# Three lines of thought about Lower Shaker Lake dam

- 1) Downsizing the NEORSD design would meet local needs
- 2) Understanding the dam failure hazards and working towards a non-Class-I project
- 3) The lake and the 15 minute city

Ben Monreal  
Shaker Heights  
Professor of Physics, CWRU

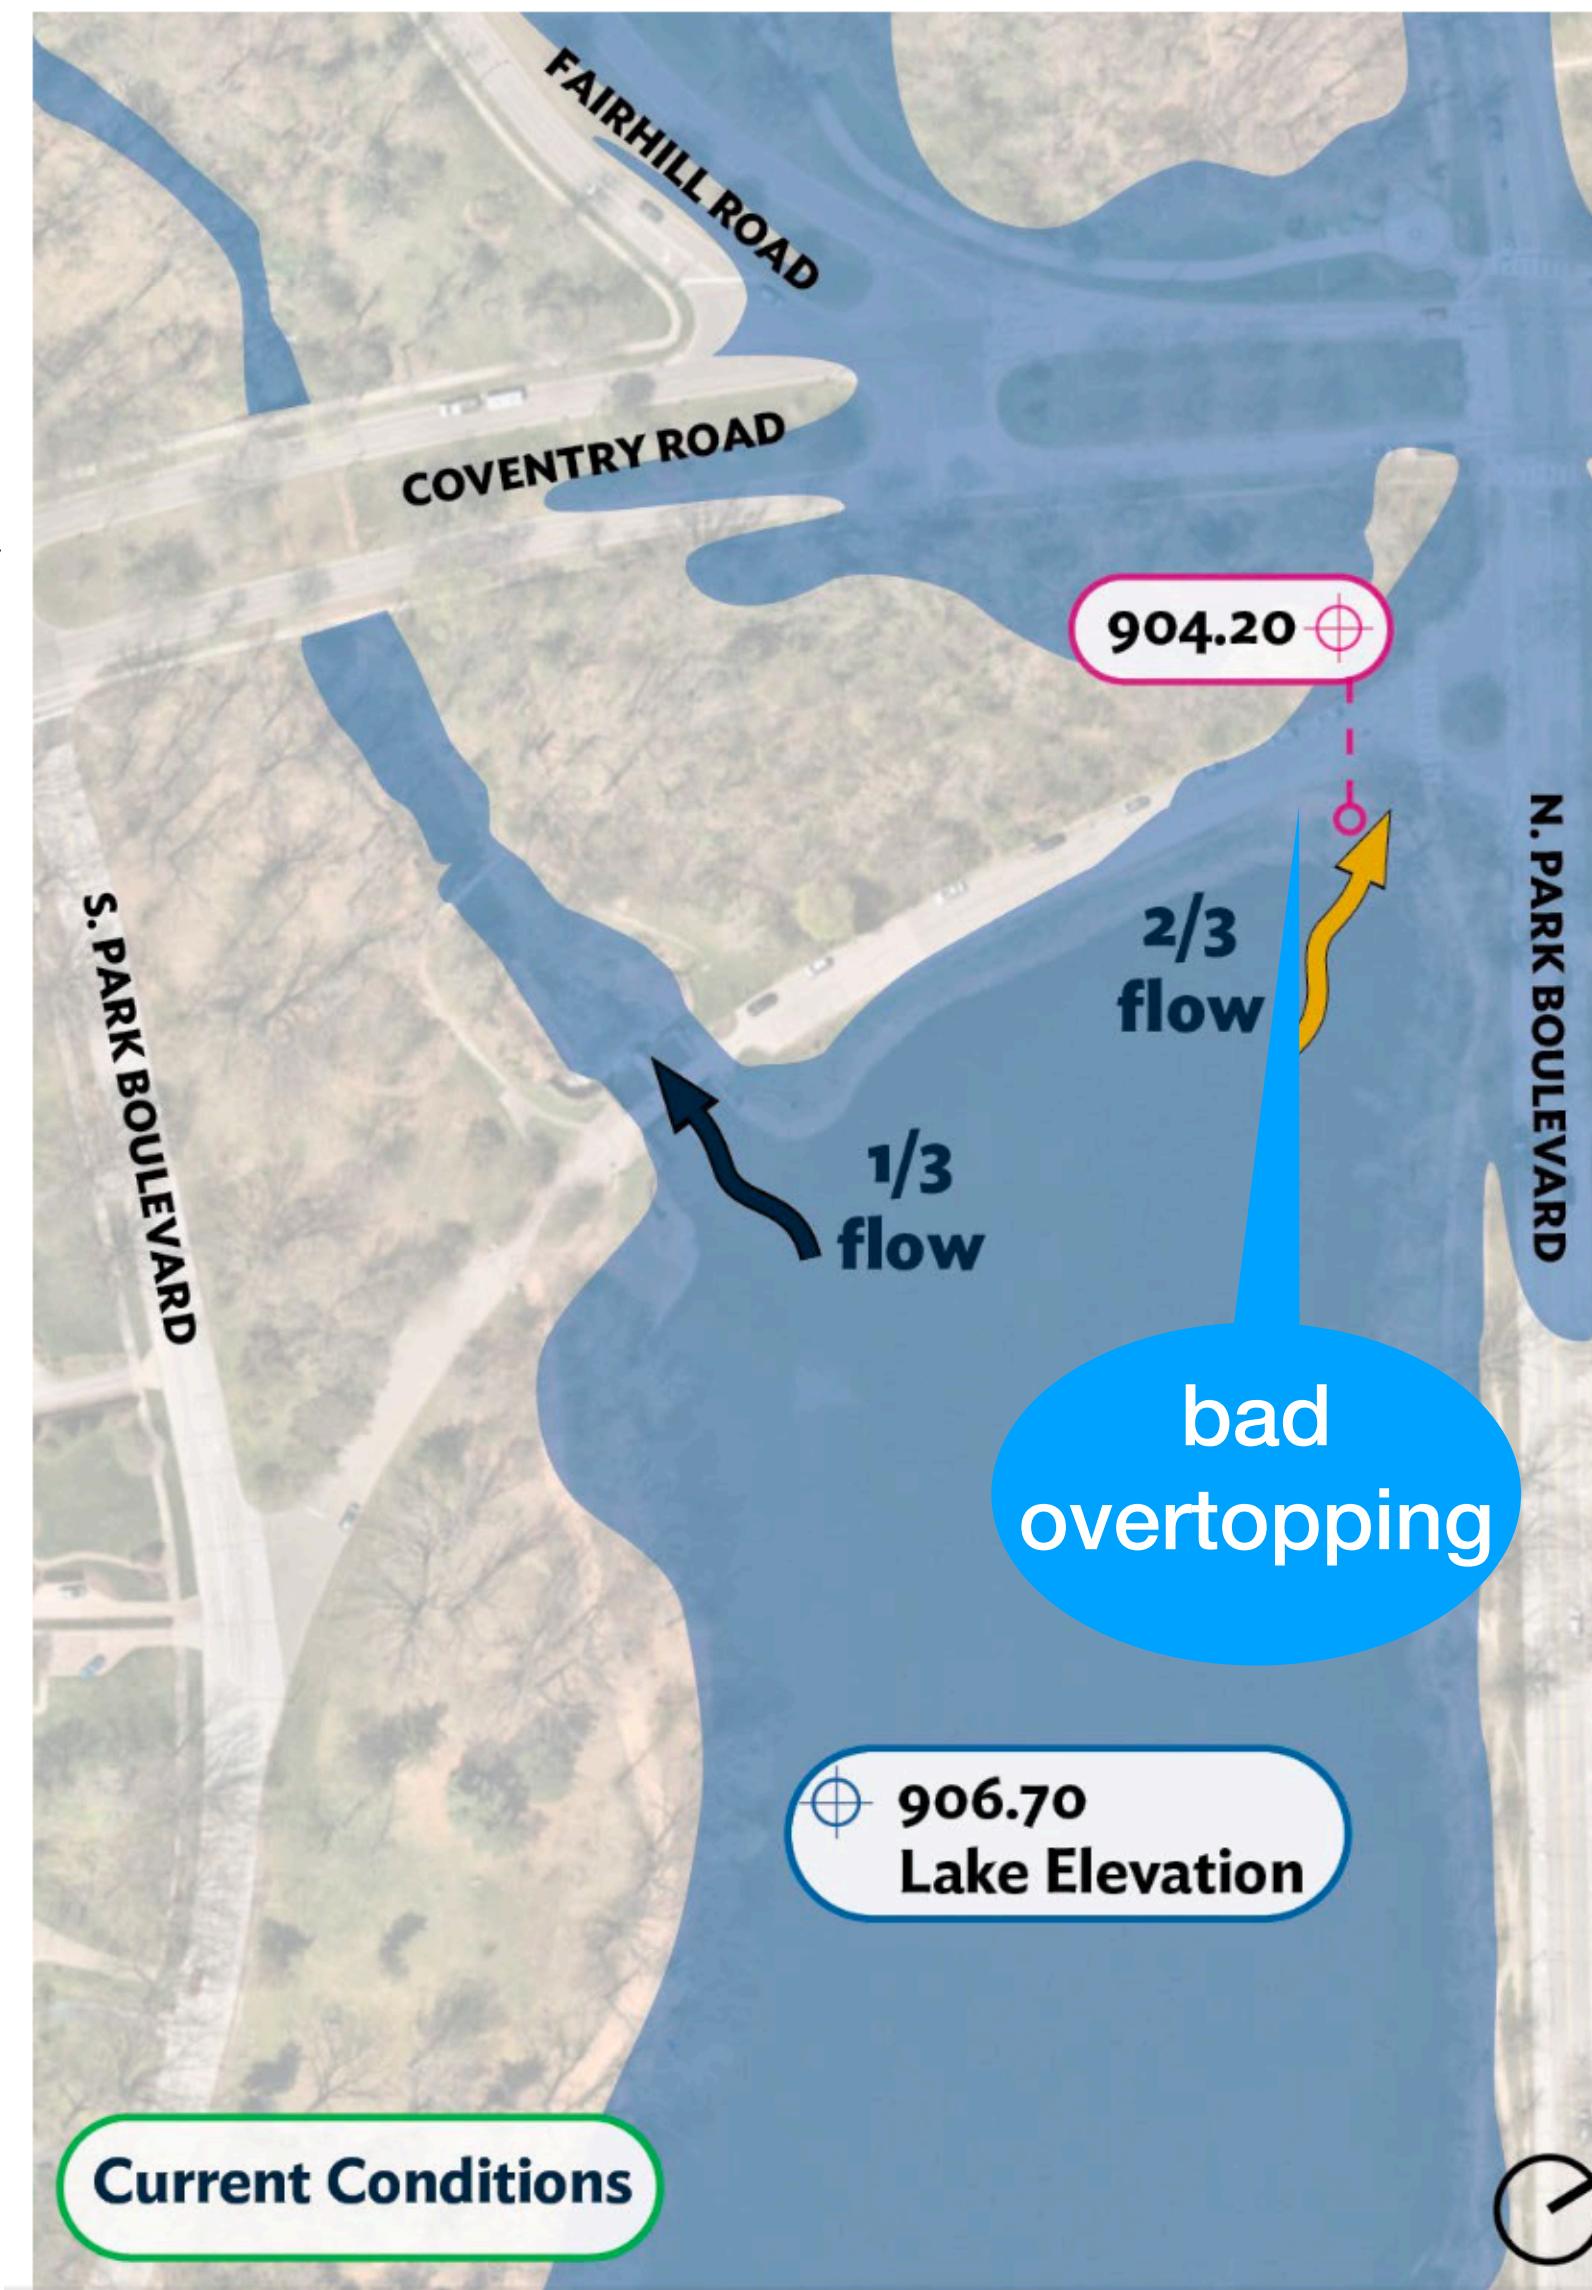
In a 5" rainstorm, the lake level is 4' above the Shaker spillway but also overtaps the dam roadway by 2'. This floods North Park. It may also erode the dam.

## Scenario 2: 5" rainstorm (1-2y)

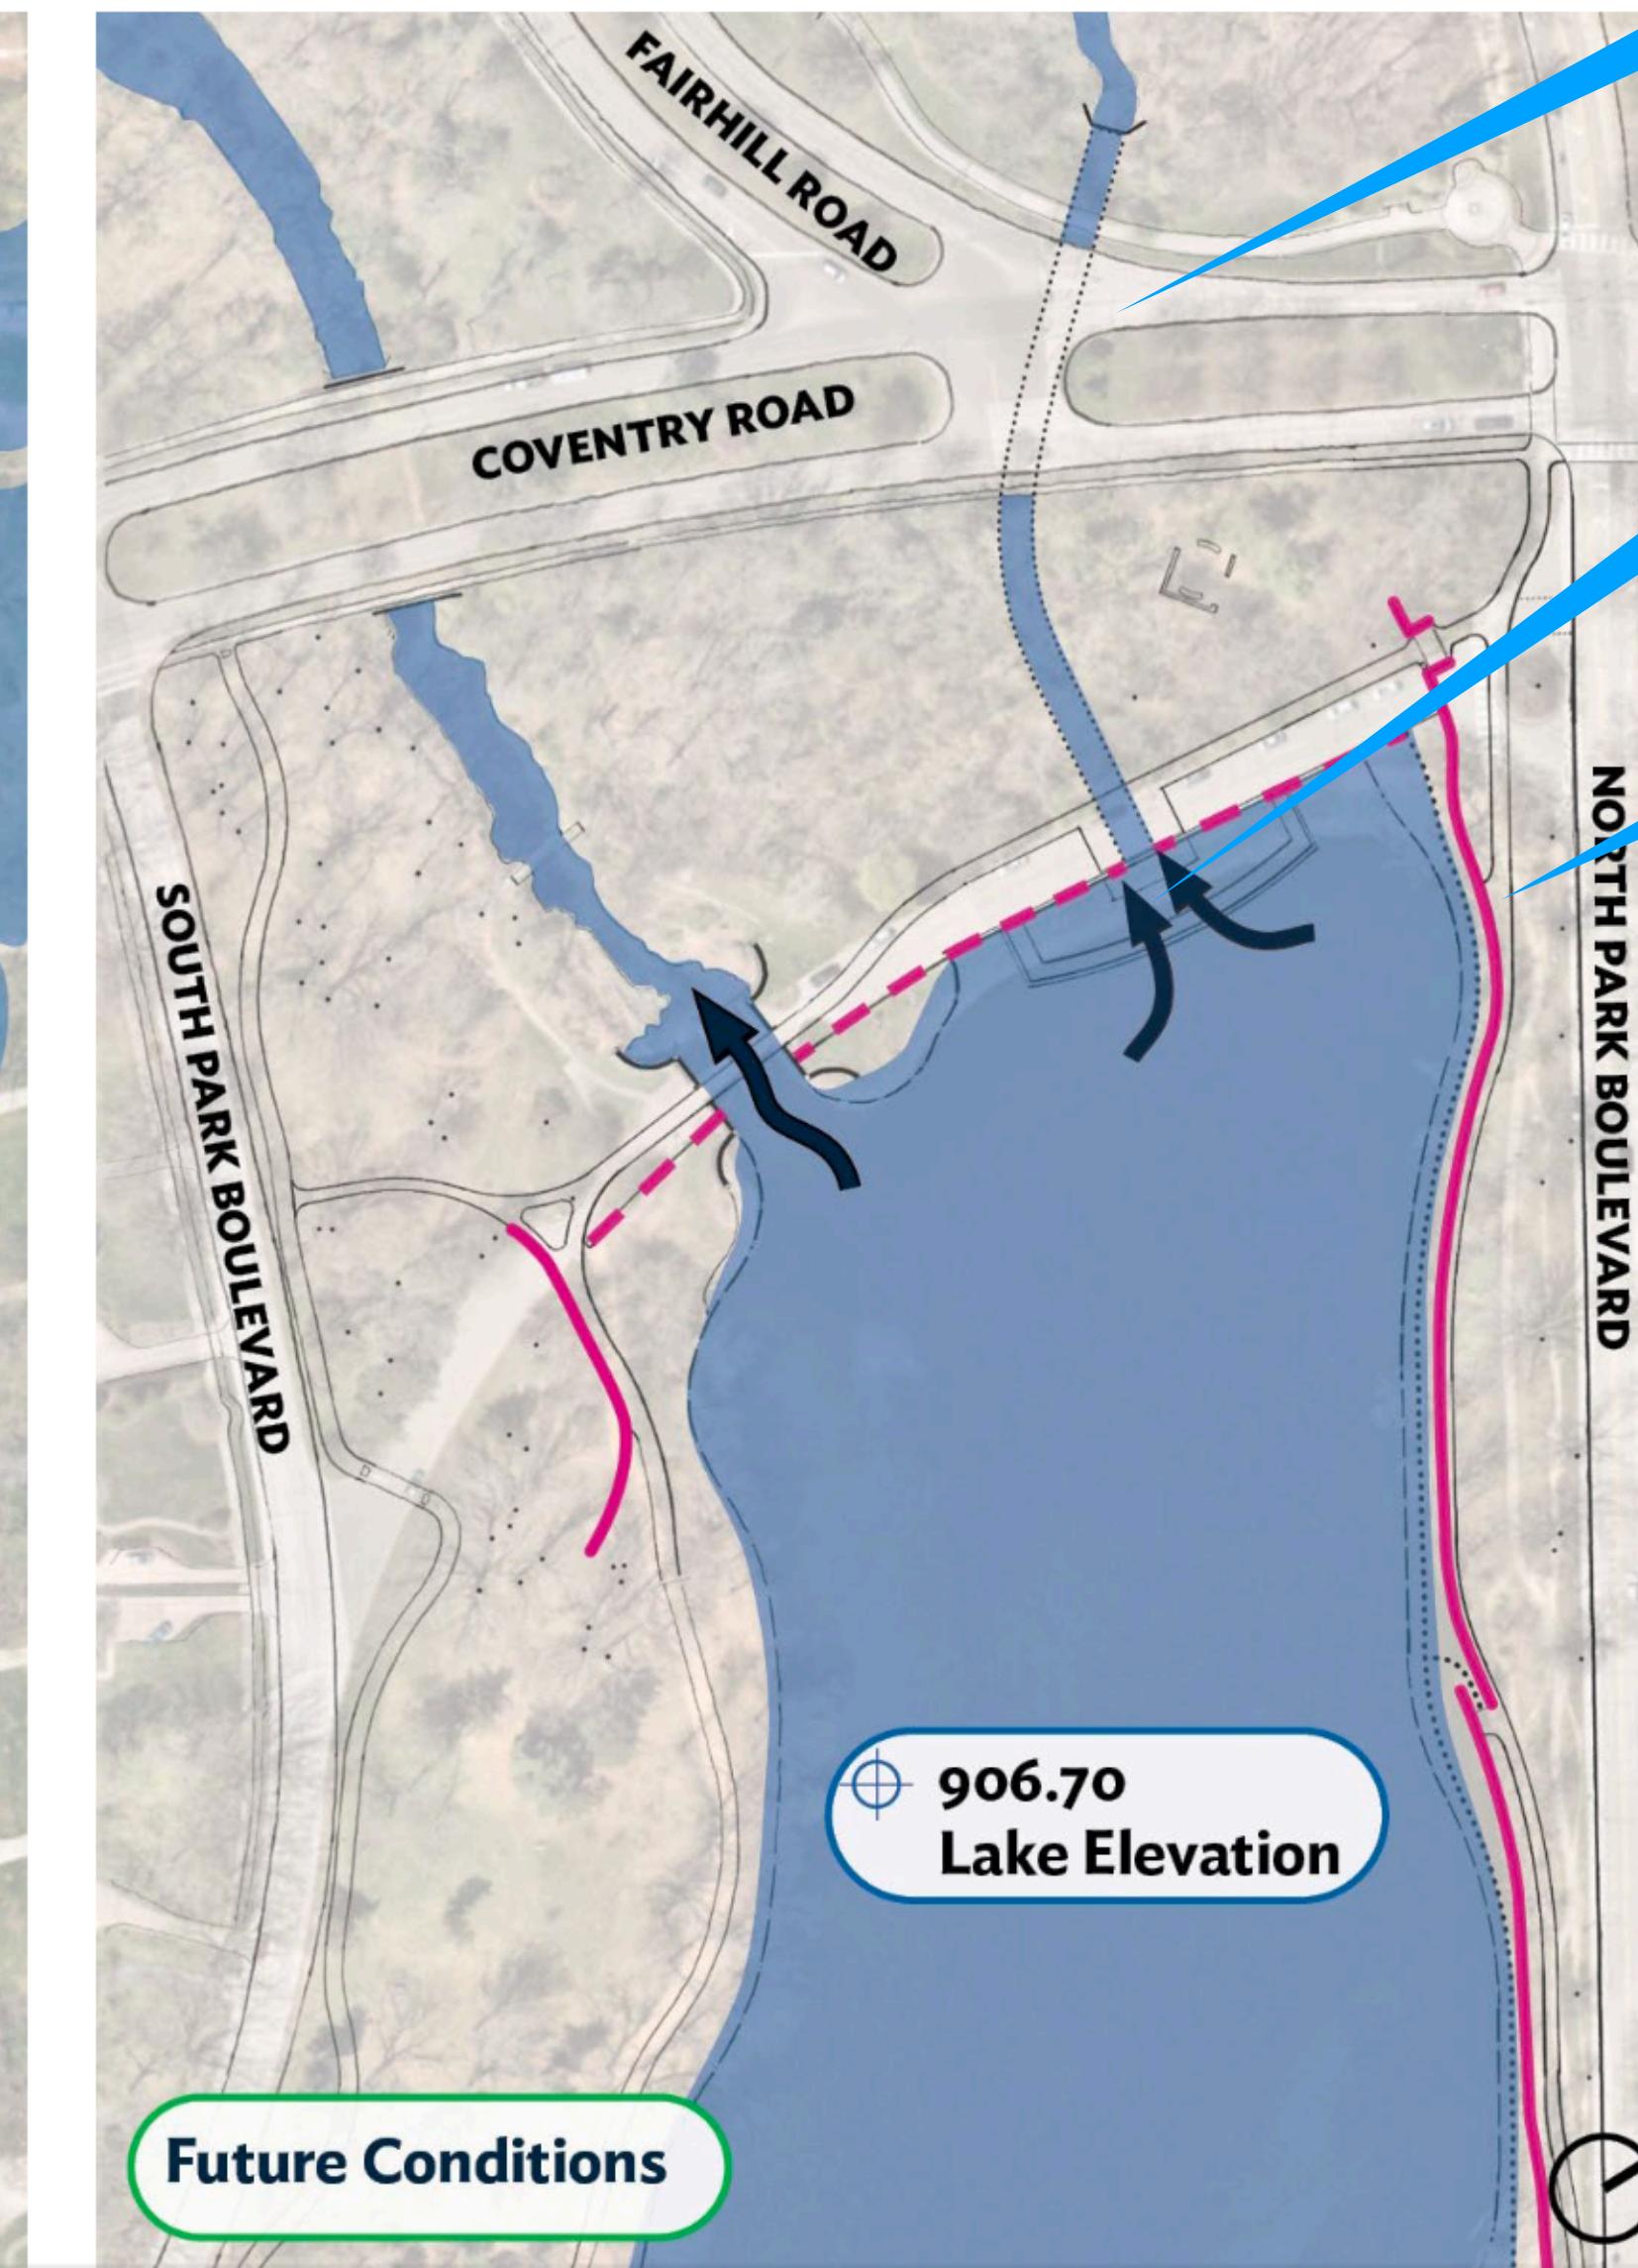
- new culvert
- new aux spillway
- floodwalls

NEORSD-24 plan adds a big auxiliary spillway at 904.2' elevation. In a 5" storm, 2' overtakes the new spillway and escapes under Coventry via a new culvert.

## Scenario 3: 17"--26" Hurricane Helene-like megaflood

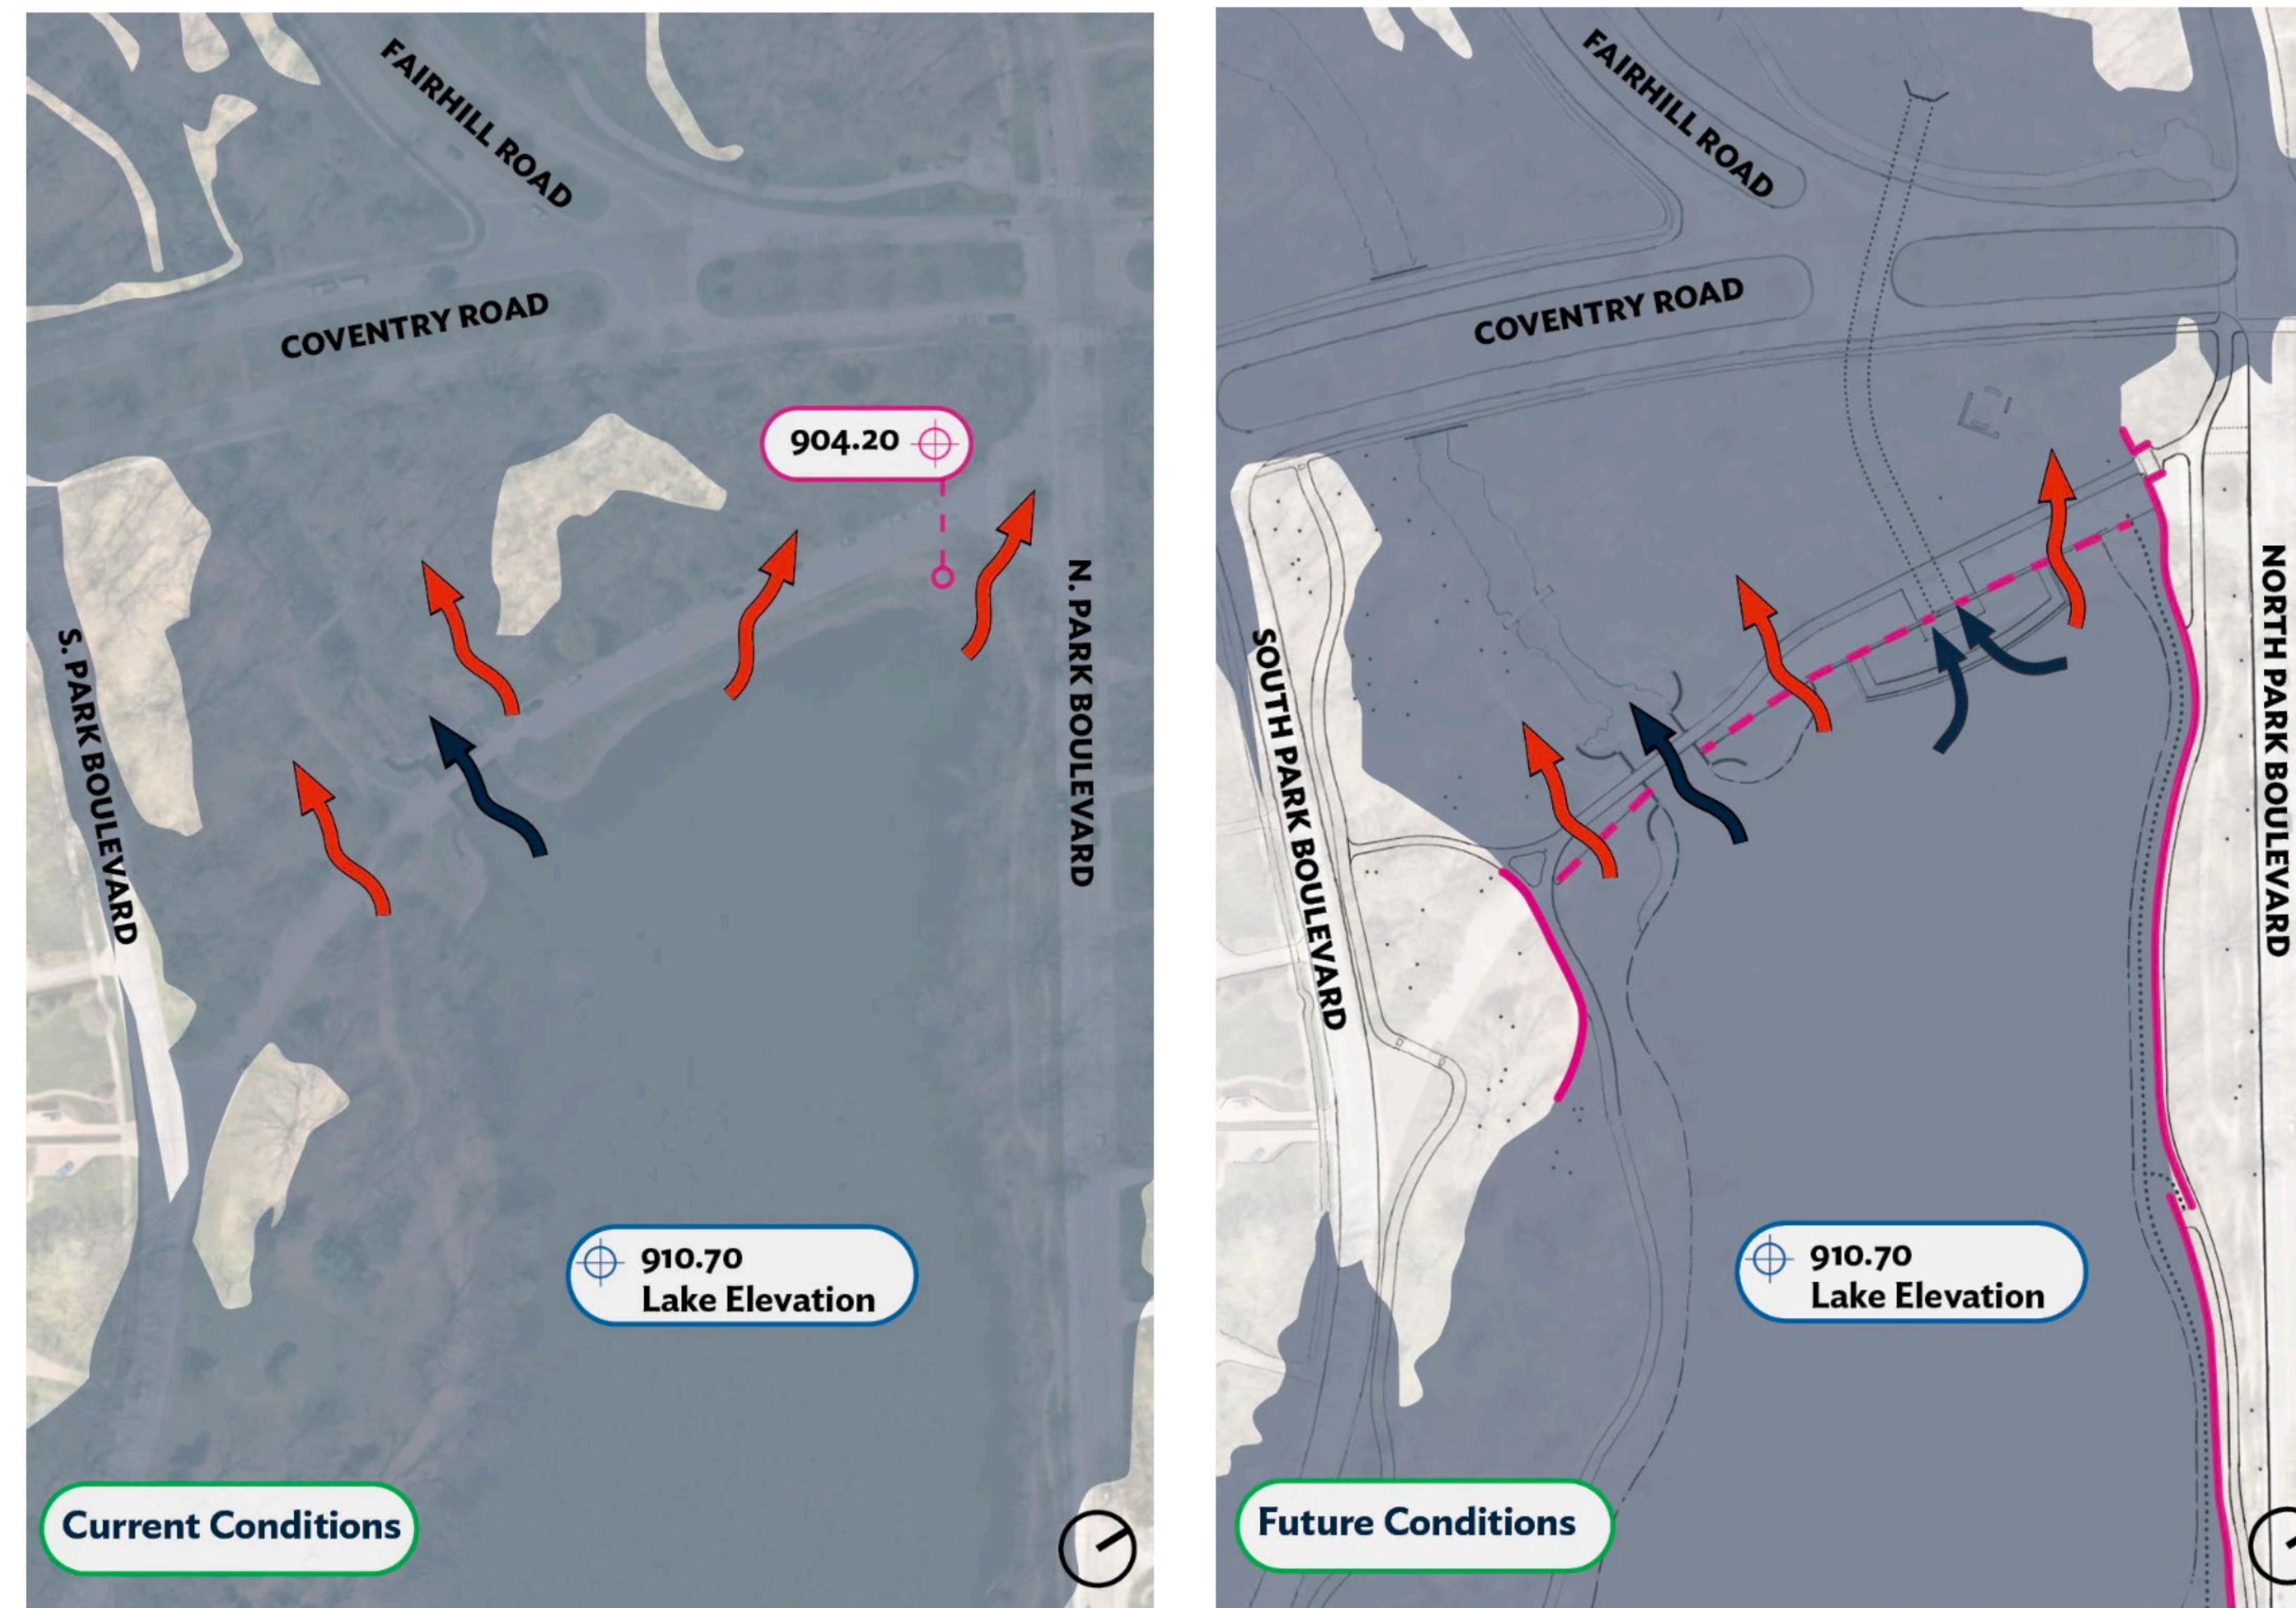
This flood isn't being caused by the dam at all, it's being caused by Coventry Road and everything downstream.

The dam crest is deep under water.

\$43,000,000 worth of Class I dam engineering later, it does not look like it has changed things much?
